Re: Aurora One – Master Plan Amendment with Adjustment
Application Number: DA-2241-08
Case Number: 2020-7004-01

Second Submission Review

PUBLIC IMPROVEMENT PLAN

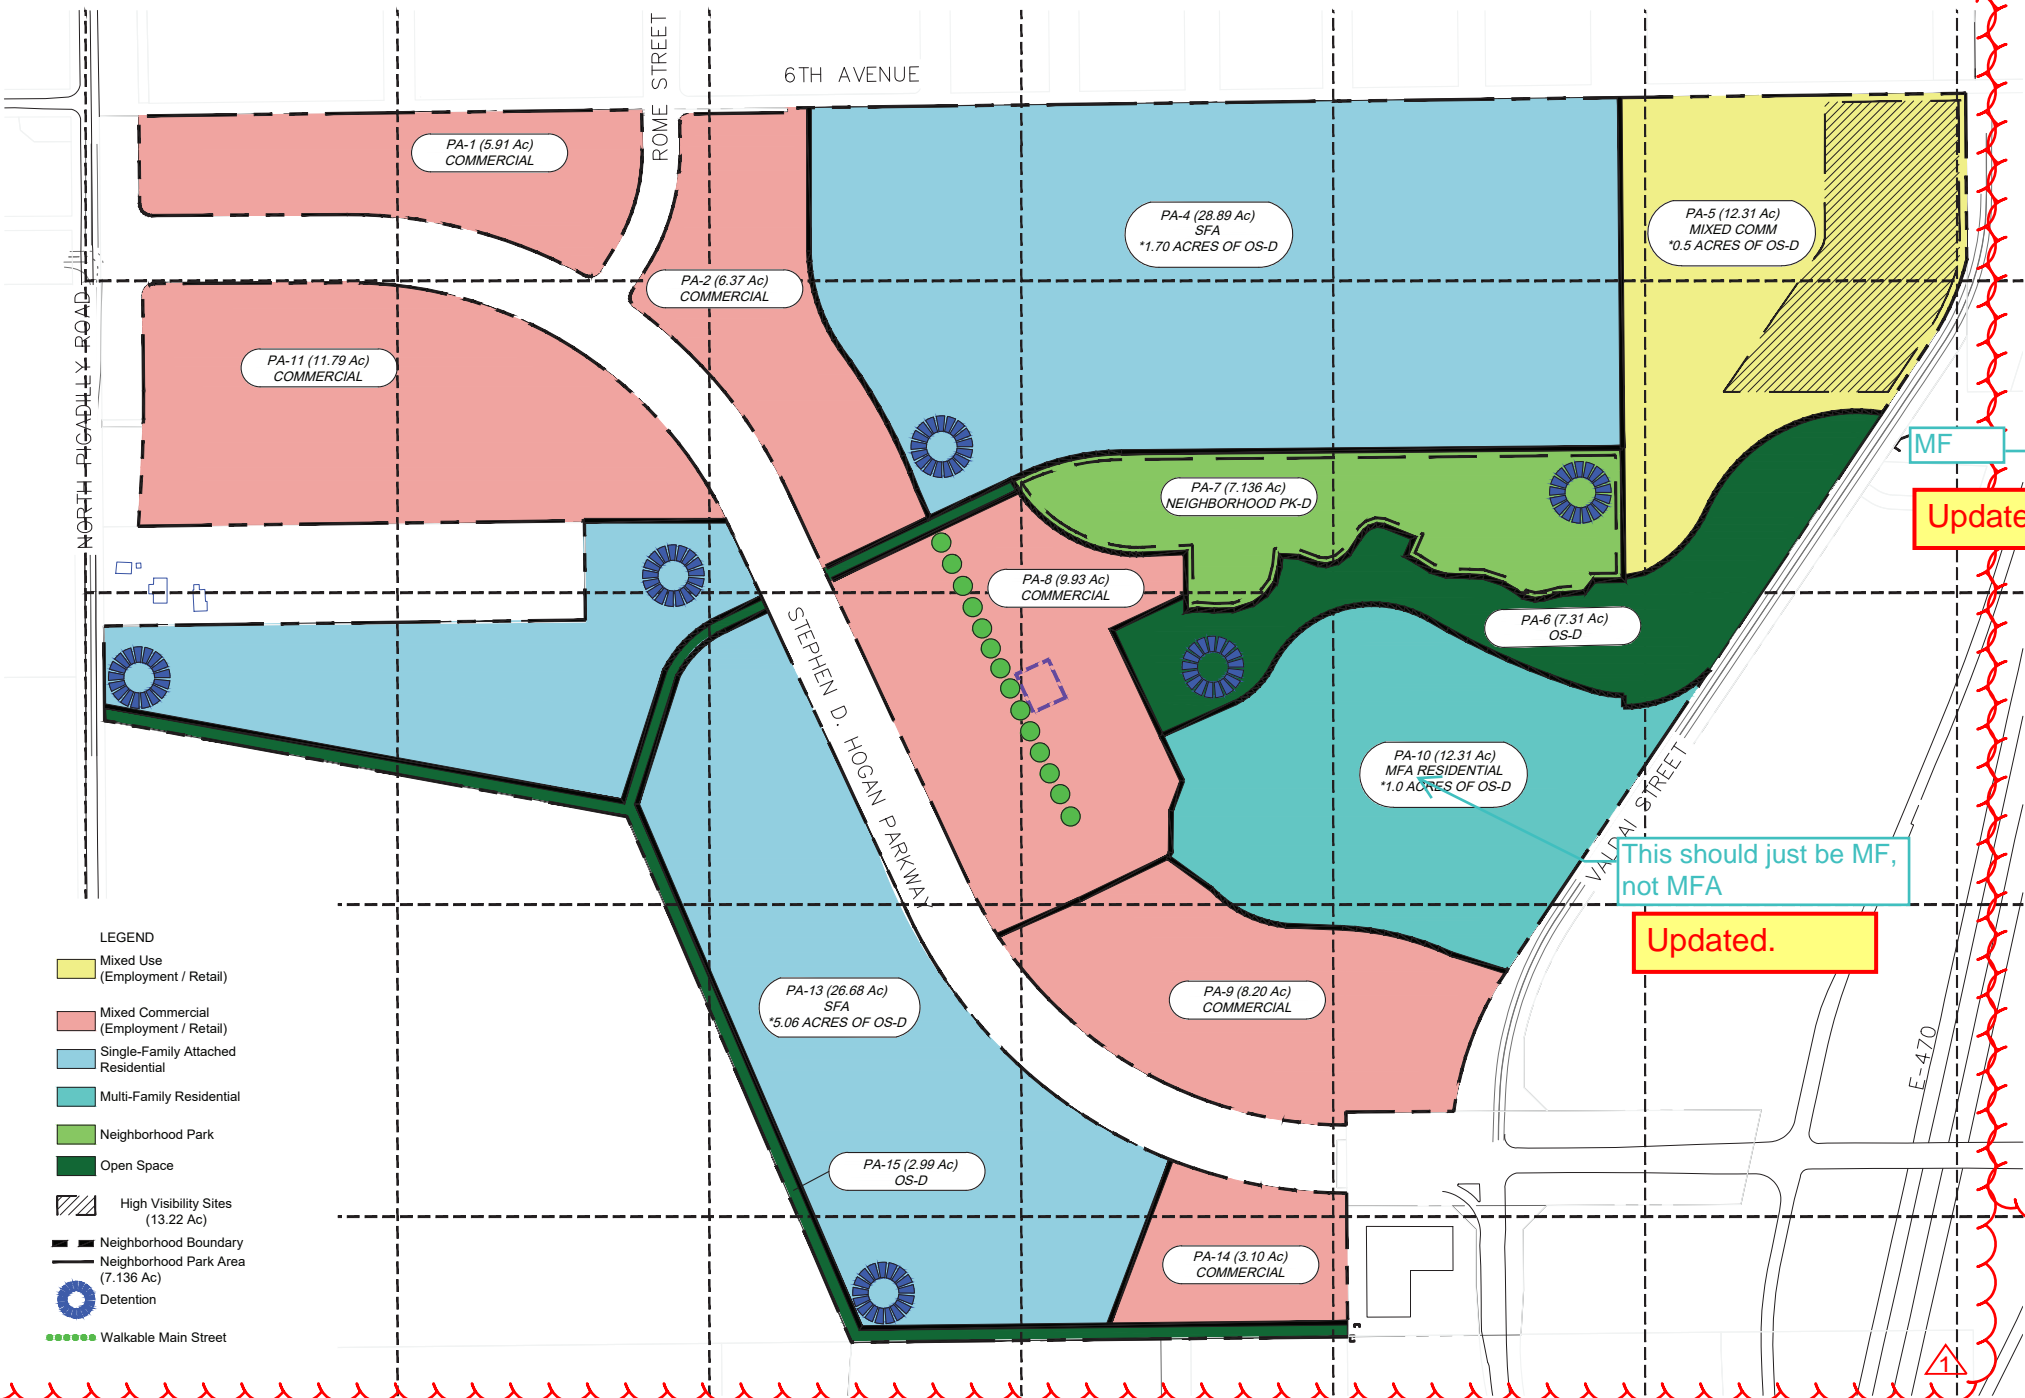
1C. The number of units noted in the Land Use Matrix should be 920 units, not 650 units. Please update.

520+400 = 920 units

Updated.

Section B: Stephen D. Hogan Parkway-4 Lane Arterial diagram.

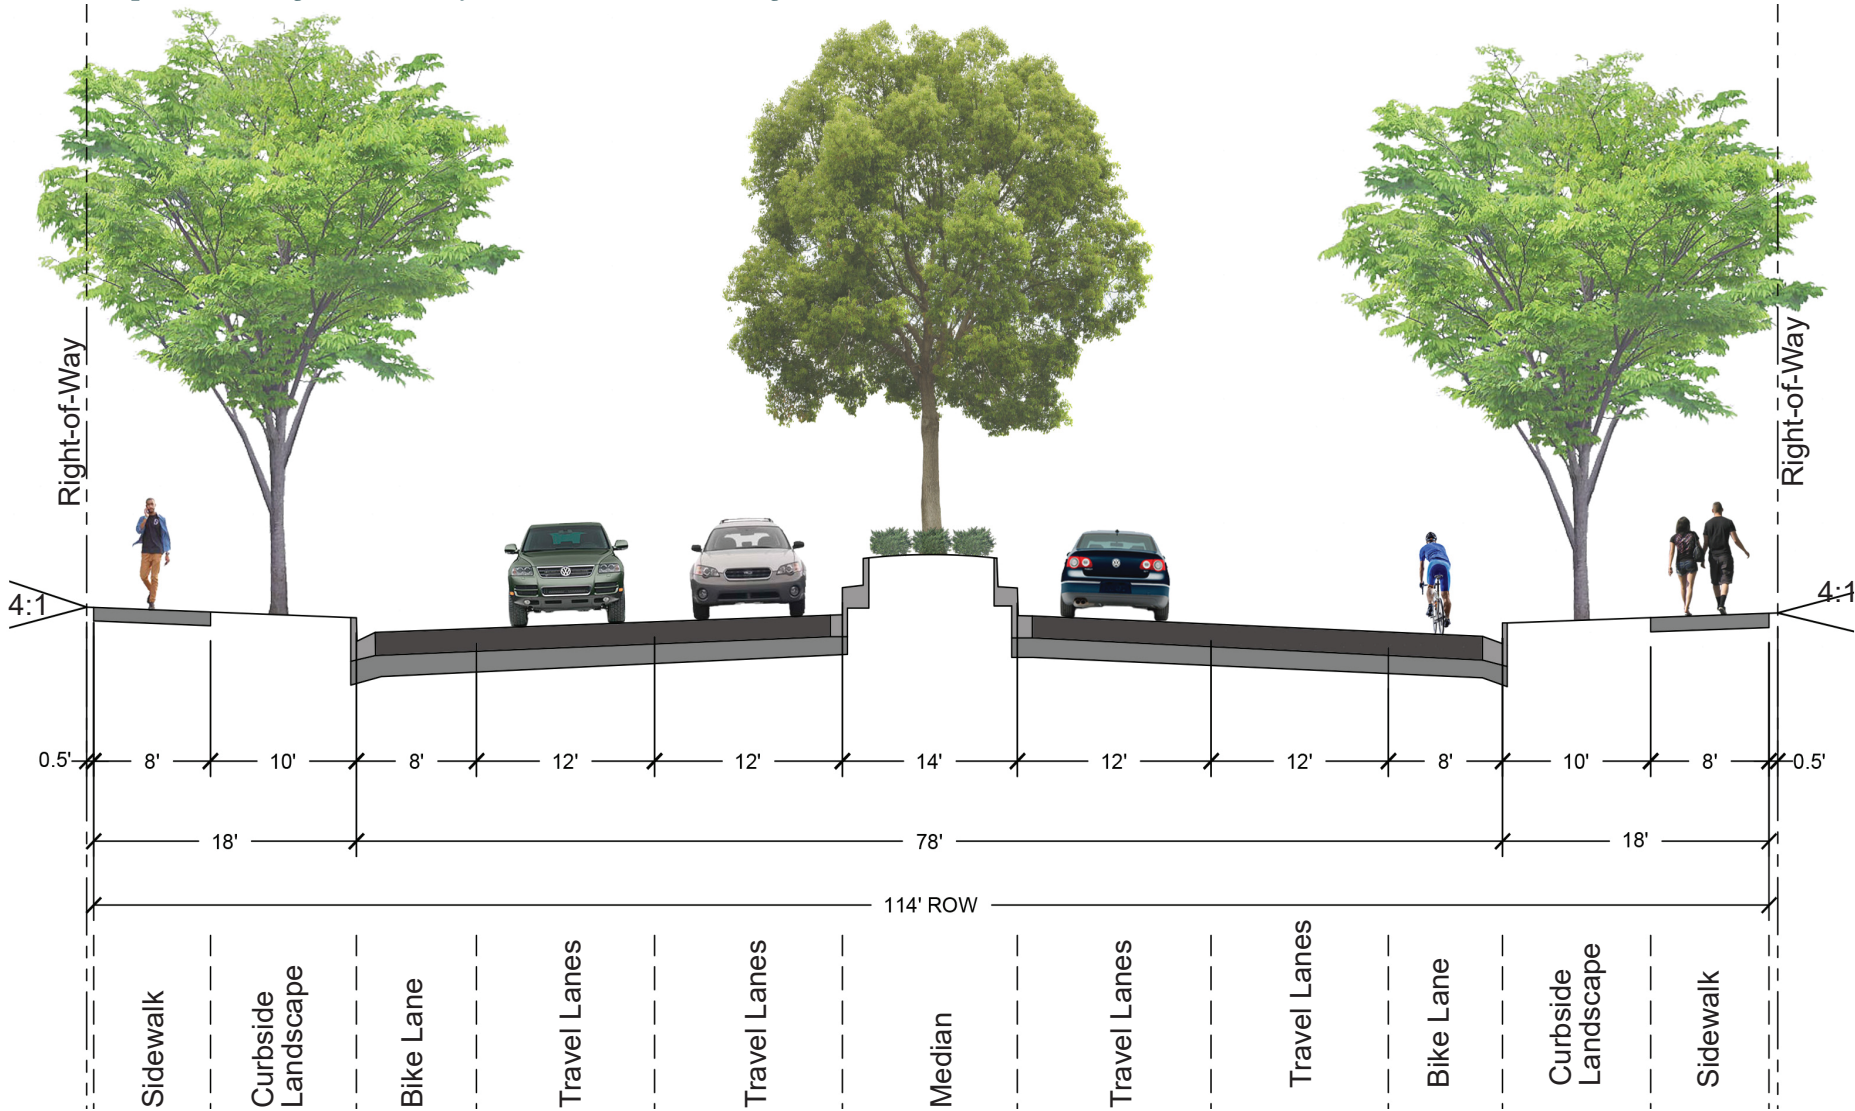
Item	Curbside Landscape	Median
PAVING MATERIALS		
CIP Concrete	Not Permitted	Not Permitted
Concrete Unit Pavers	Not Permitted	Remove this. The lighting will be reviewed/approved as part of the civil plans and should not be defined to this level on the master plan.
Stone Pavers	A maximum of 10% of the Curbside Landscape area, measured by block.	Not Permitted
Compacted Crusher Fines	A maximum of 10% of the Curbside Landscape area, measured by block. This may not be used as a mulch treatment between shrub beds.	Not Permitted
AMENITIES		
Street Lighting	Required: 1 per 250' LF	As required by photometric study
Pedestrian Lighting	Permitted	Not Permitted
Benches	Not Permitted	Not Permitted
Trash Receptacles	Not Permitted	Not Permitted
Bike Racks	Required: No less than 2 bike racks with a minimum capacity of 3 bikes each at intersections with public streets and/or pedestrian corridors.	Not Permitted
Café Seating	Not Permitted	Not Permitted

Section C: Crossroads Boulevard/Valdai and Rome Street 3-Lane Collector

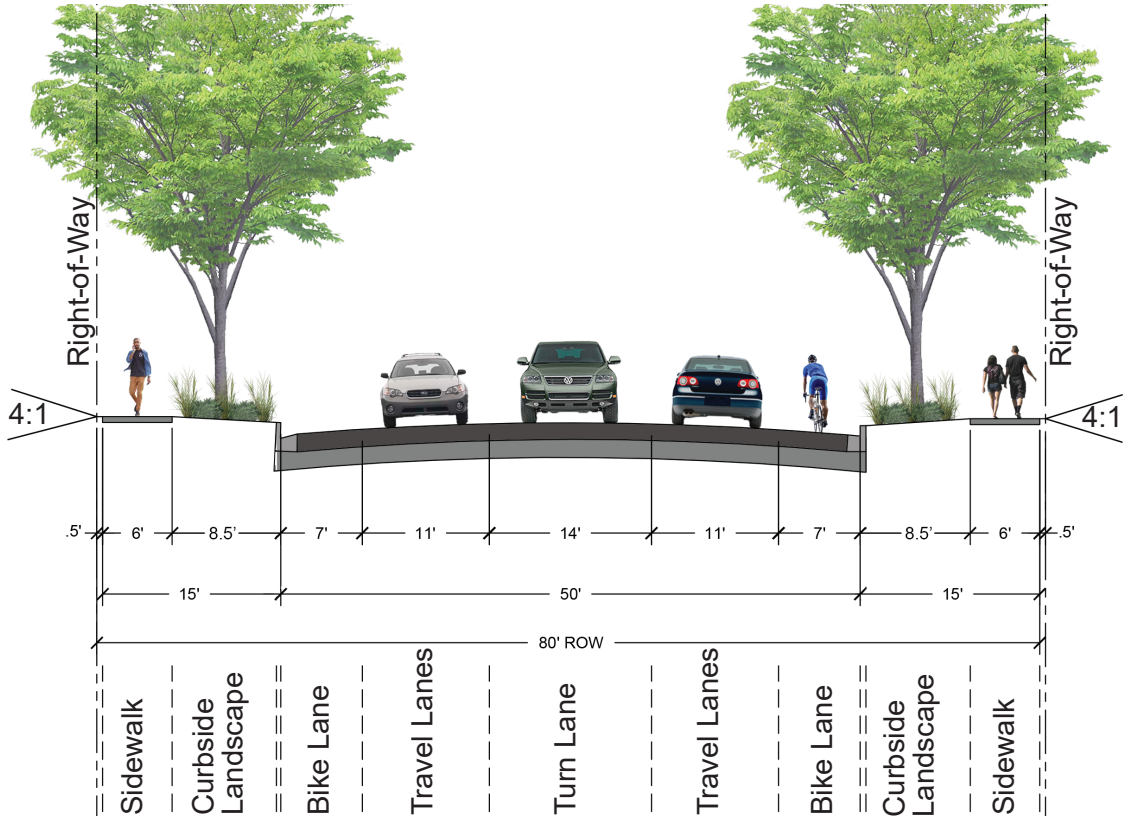
Remove this. The lighting will be reviewed/approved as part of the civil plans and should not be defined to this level on the master plan.

Updated.

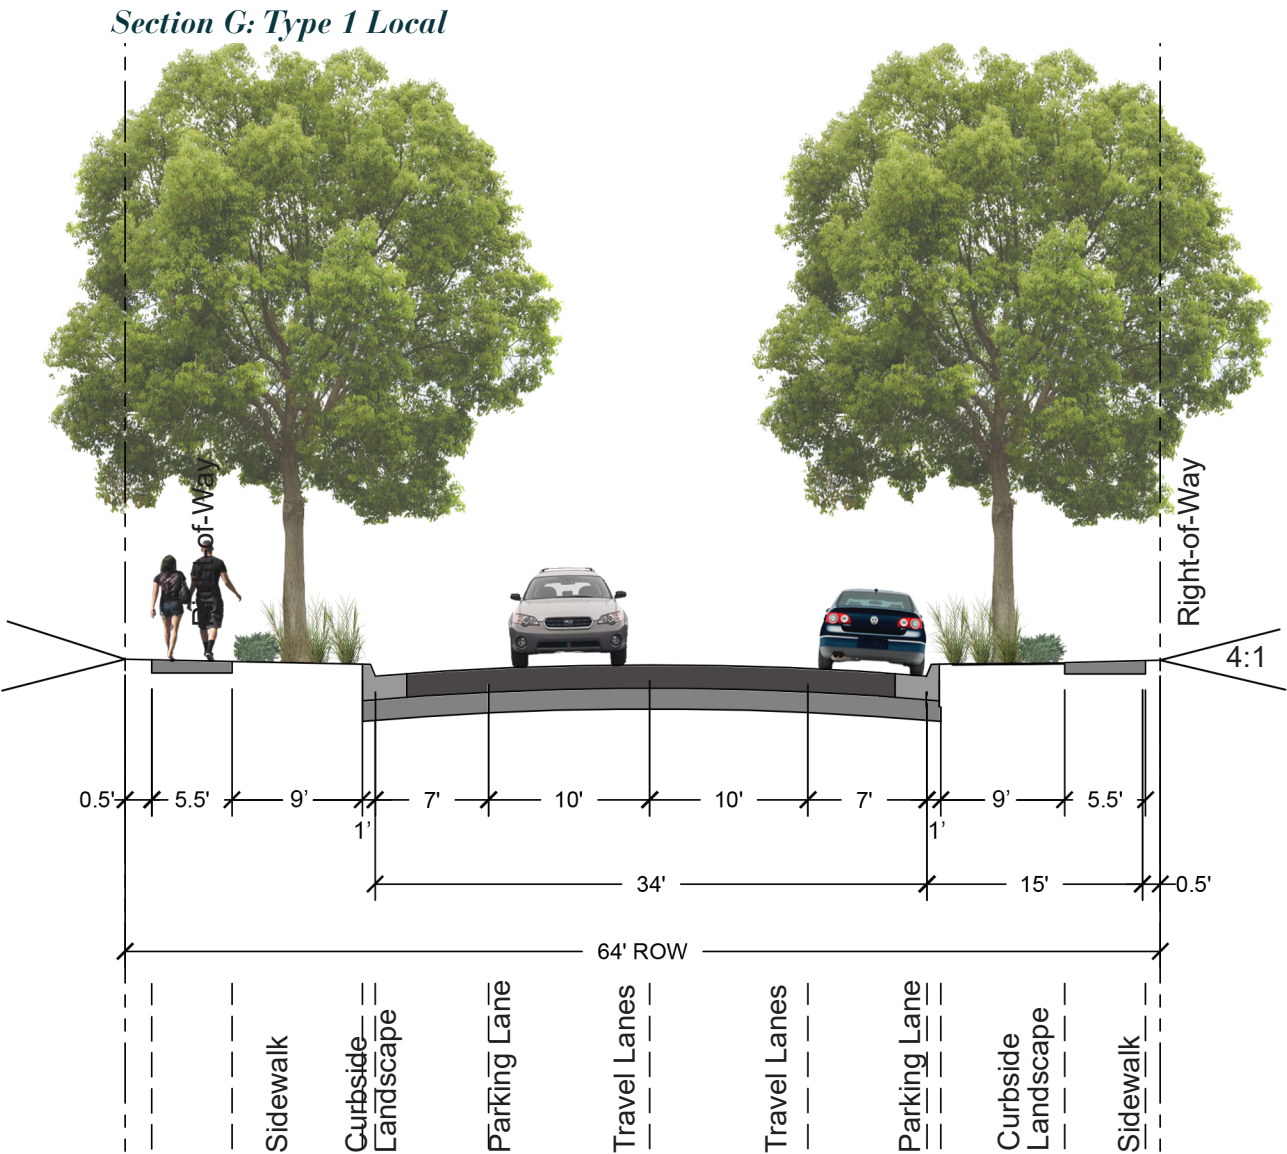
Remove this. The lighting will be reviewed/approved as part of the civil plans and should not be defined to this level on the master plan.

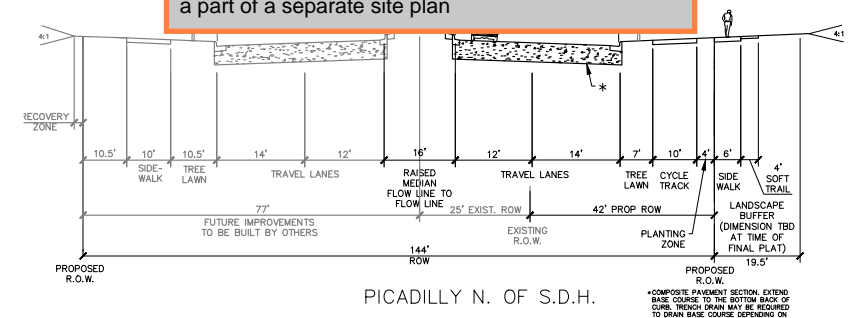
Per NEATS, Picadilly is 6-lanes north of SDH/6th and 4-lanes south of SDH/6th. Please show 2 sections, one for north of SDH and one for south of SDH. The section south of SDH should match the Eagle Ridge MP section including 114' of ROW, 14' detached walk, 10' landscape, 14' & 12' travel lanes, and 14' raised median.

The section north of SDH should be the same as the previously approved master plan and the Horizon Uptown master plan.

Ware Malcomb Response: This section has been replaced with a section showing the NEATS required 6 lane arterial, north of SDH, to match the surrounding master plans. A note has been added indicating that the 23' drive aisle from the Horizon Uptown Development will be terminated by others as a part of a separate site plan

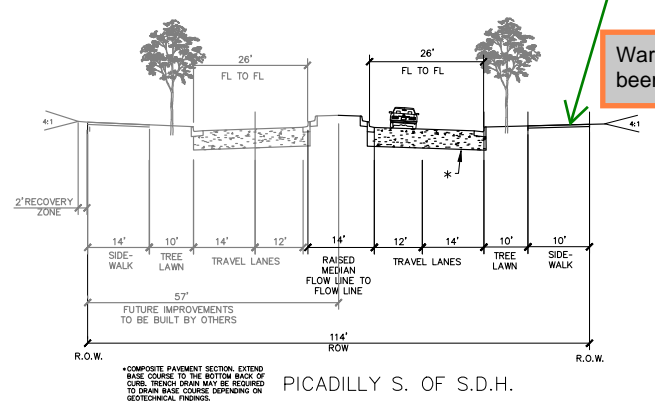
Revise to a 14' walk.

Ware Malcomb Response: Sidewalk has been revised to 14'
